A12 Chelmsford to A120 DCO Review

Alternative De-trunking Proposals

Technical Note

March 2023

DRAWING NO. **B3553RB1-01-00-001** REV. -

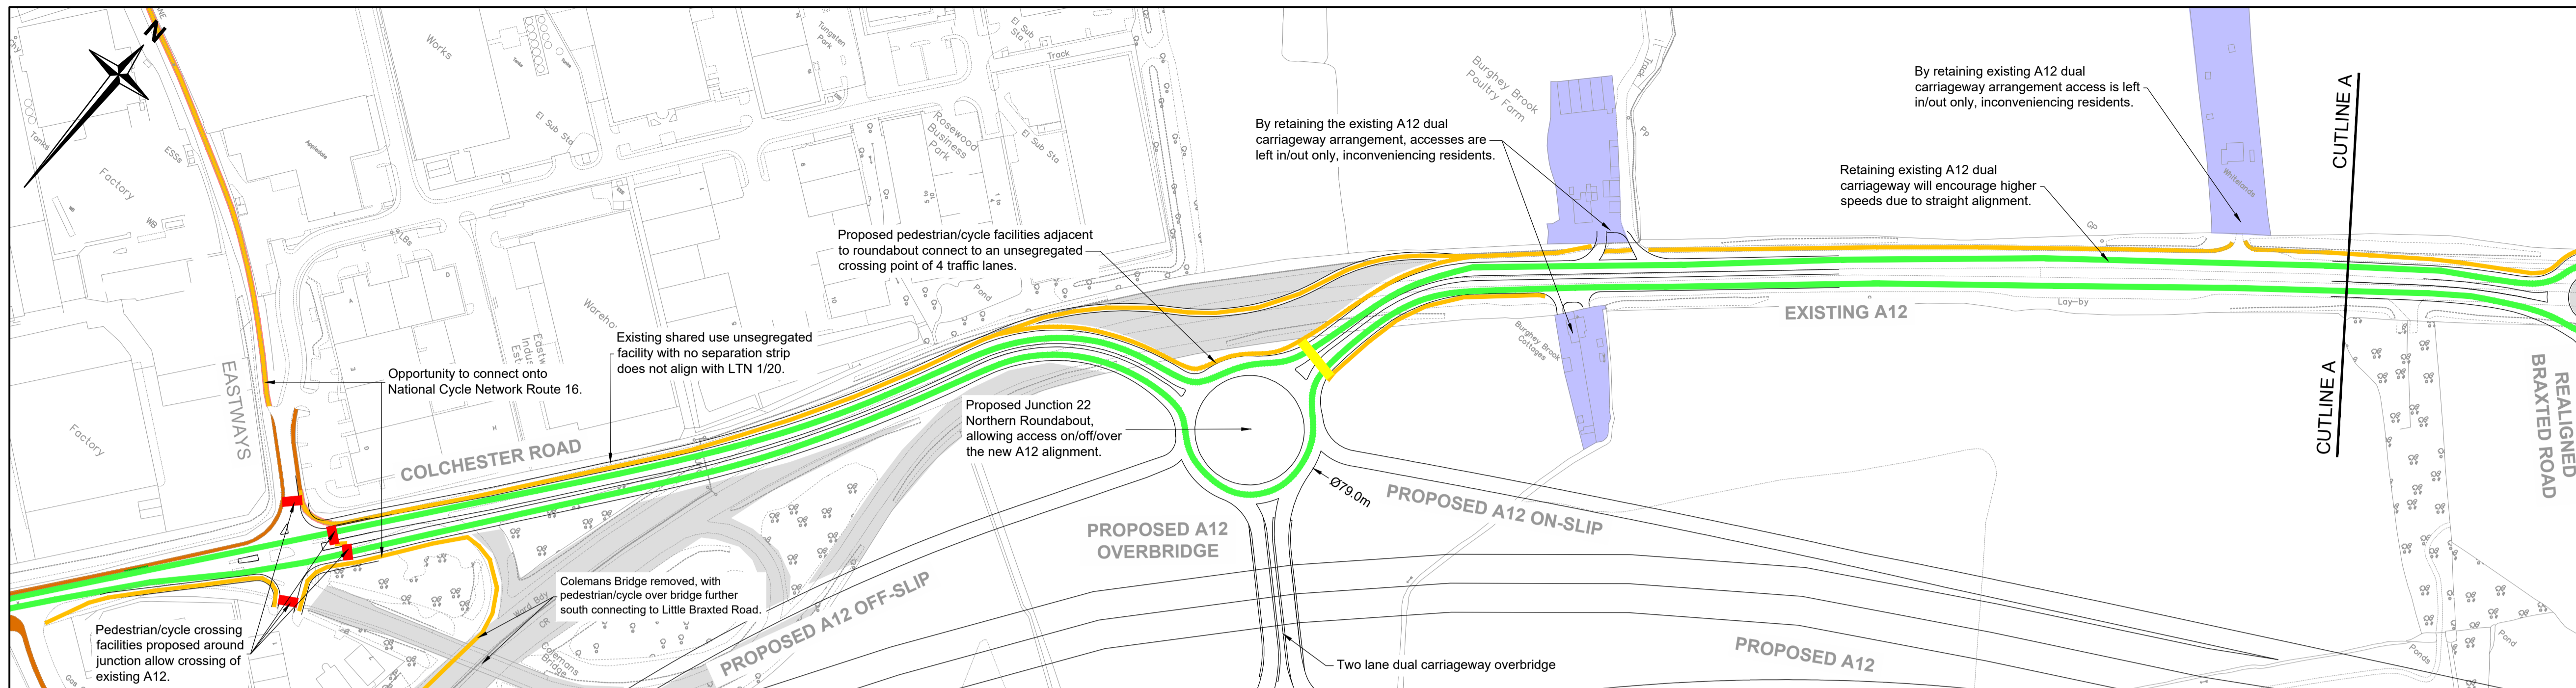
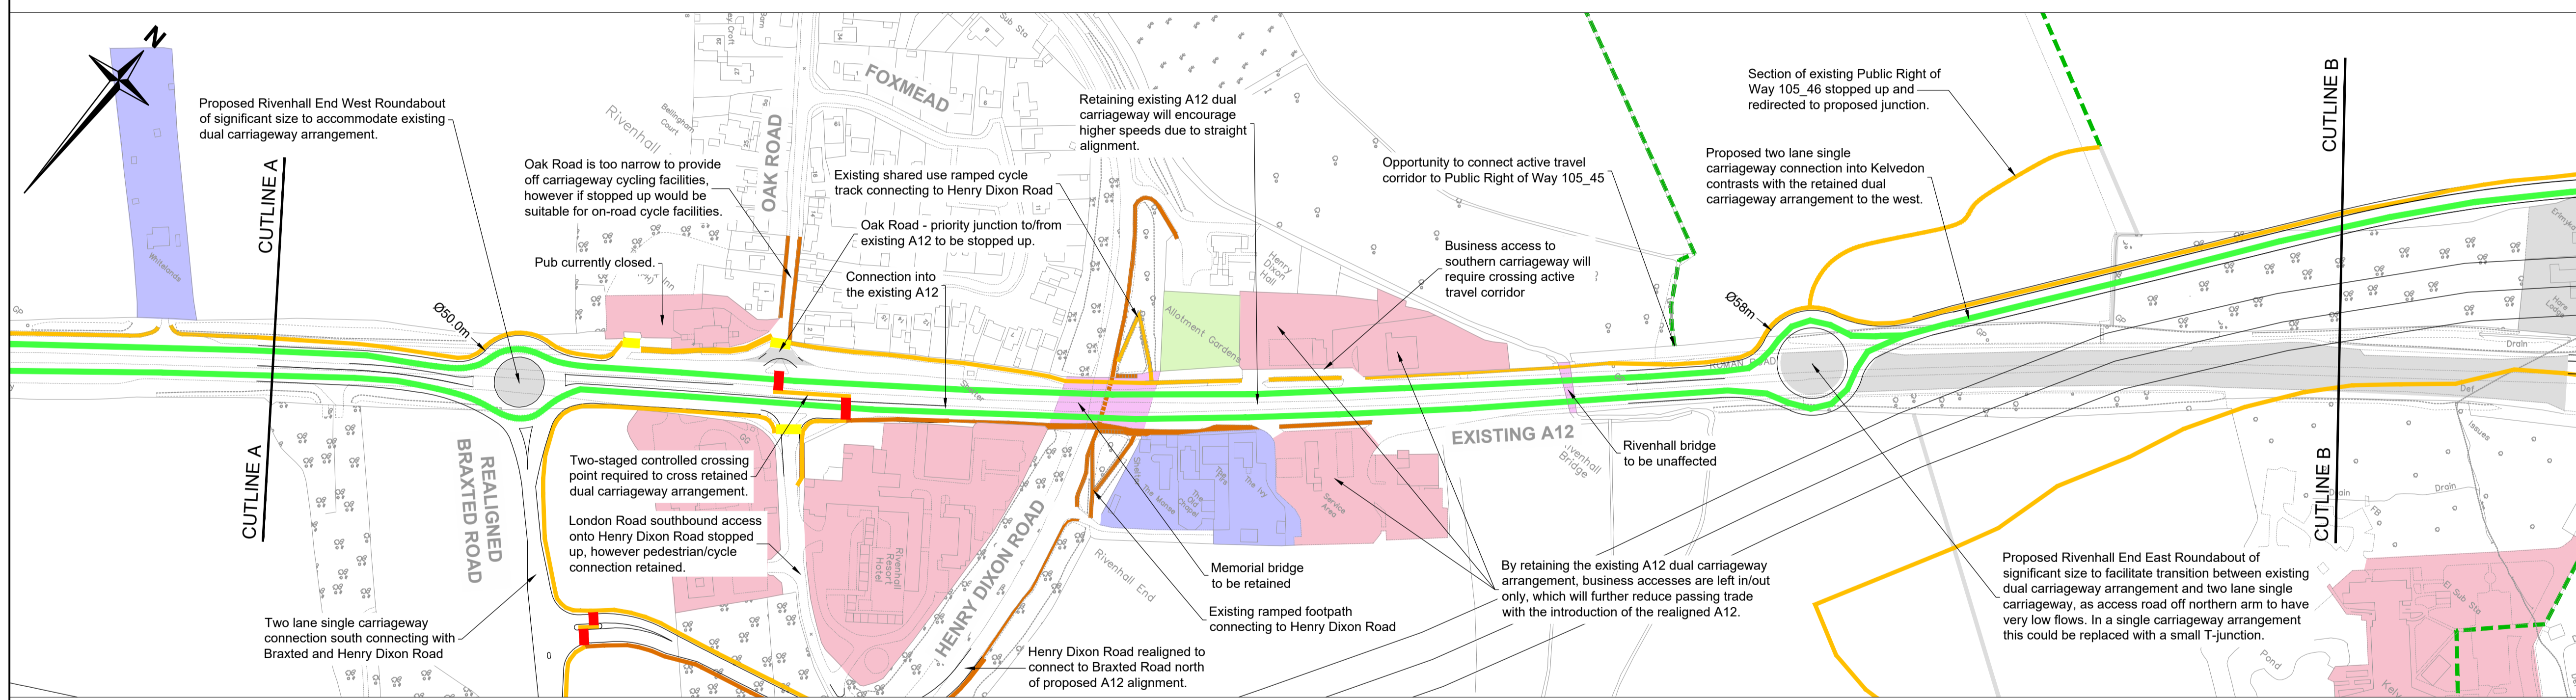
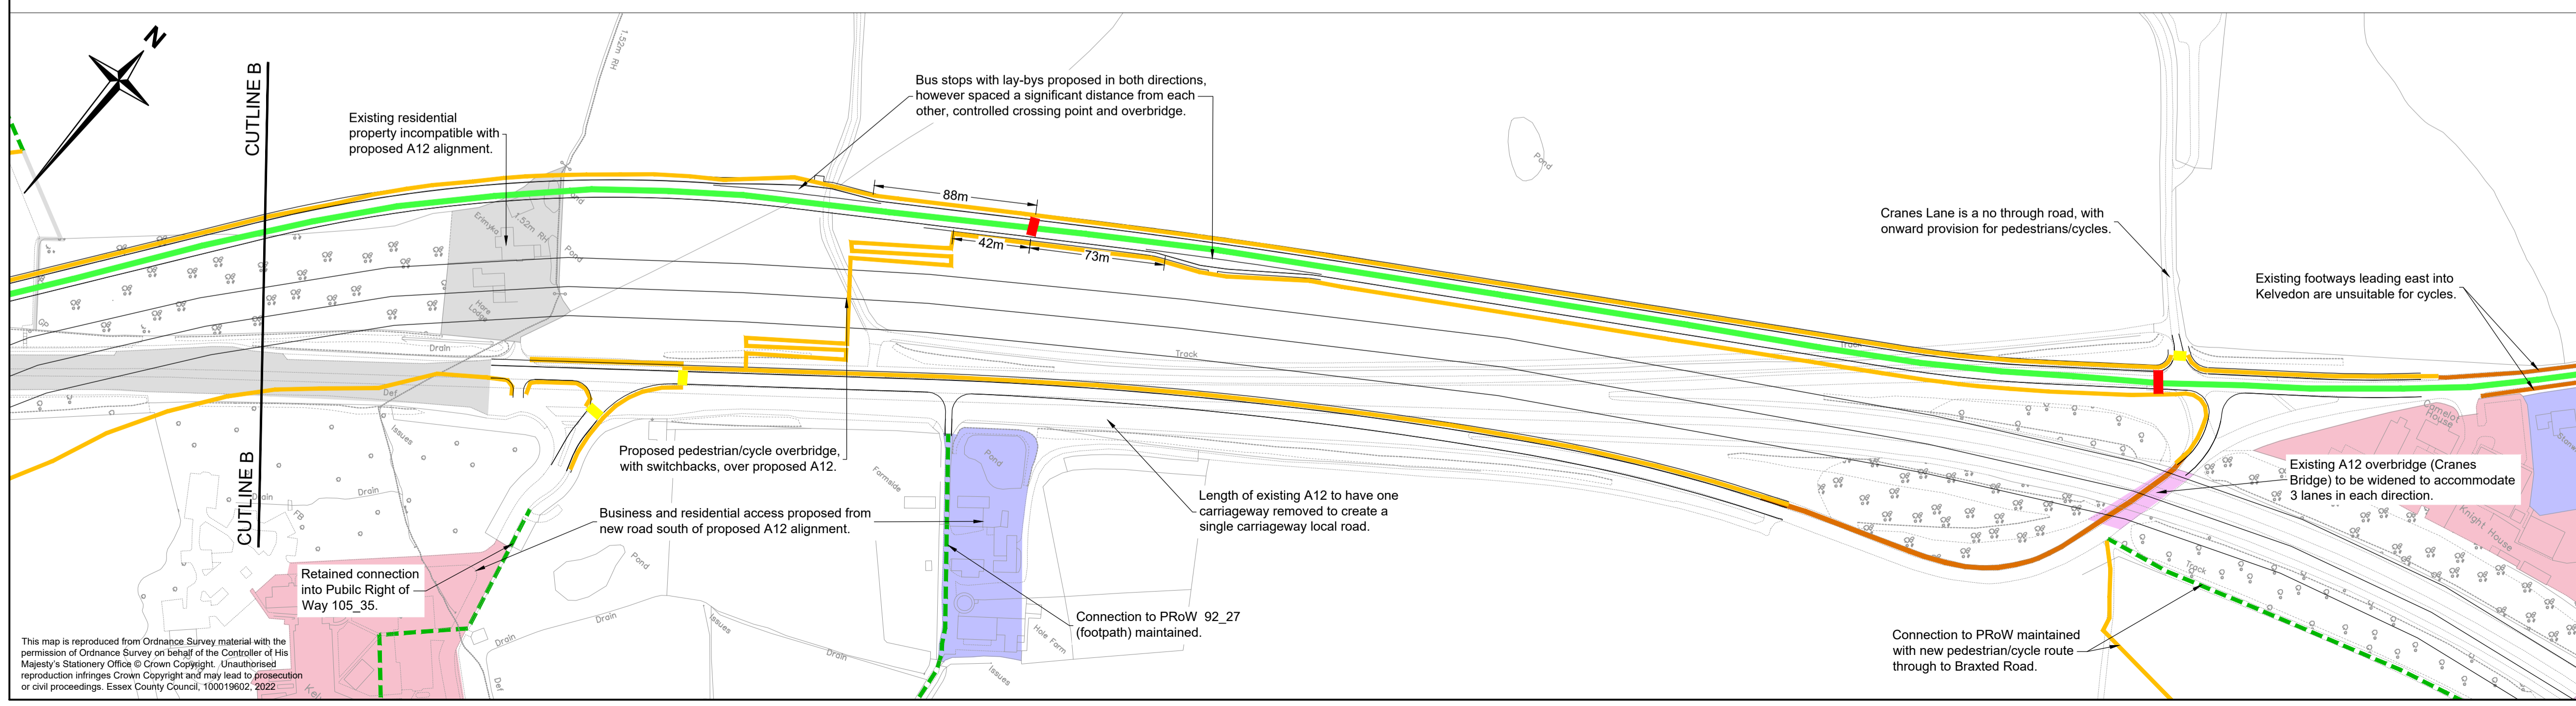
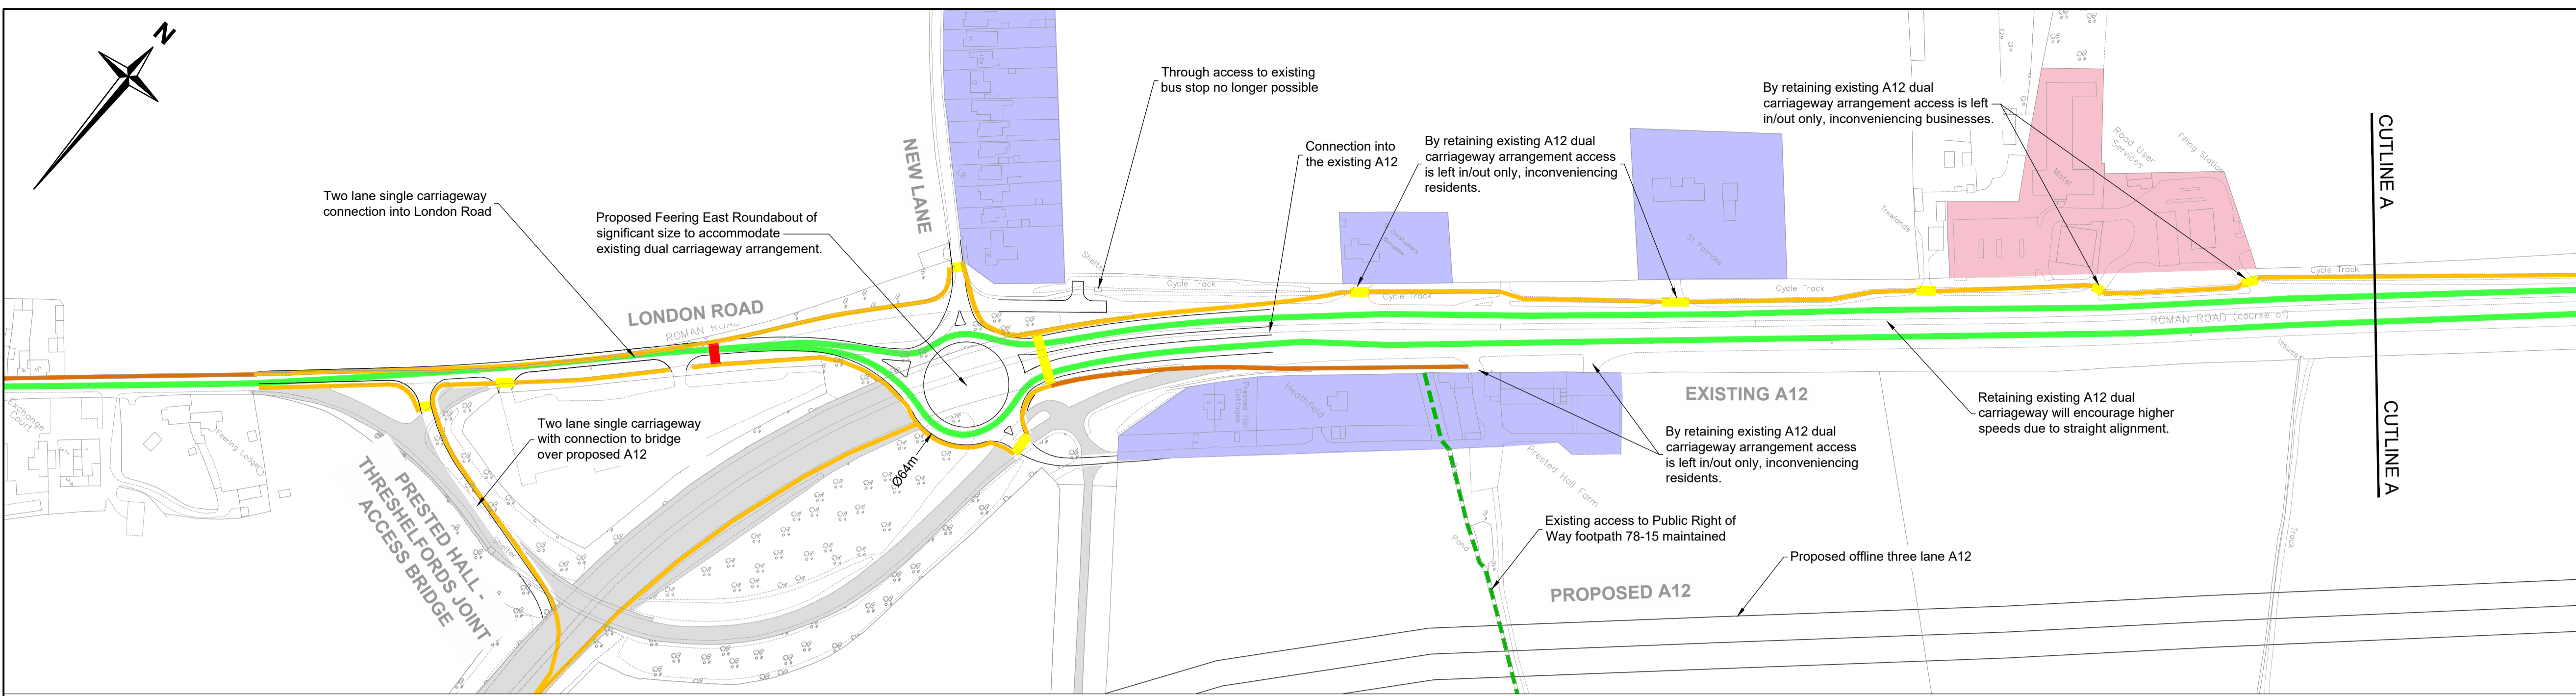
- NH make use of existing pedestrian/cycle facilities along the corridor alongside their own proposals for new infrastructure to provide continuity of these facilities. However, the existing shared use facility adjacent to the eastbound (northern) carriageway is of a poor quality and substandard (approximately 2.0m to 2.5m in width) which does not align with the latest cycle design guidance set out in LTN 1/20. It is unclear if these existing facilities would be widened and to what width. Regardless the proposals appear to still be of a shared use format, with minimal set back from the retained carriageway.

- Within Rivenhall End there is an existing access onto Oak Road for eastbound traffic and an indirect access onto Braxted Road for westbound traffic. NH proposes to stop up Oak Road and remove the ability for vehicles to access Braxted Road by turning south from the westbound carriageway opposite Oak Road (access being relocated to the new Rivenhall West roundabout).
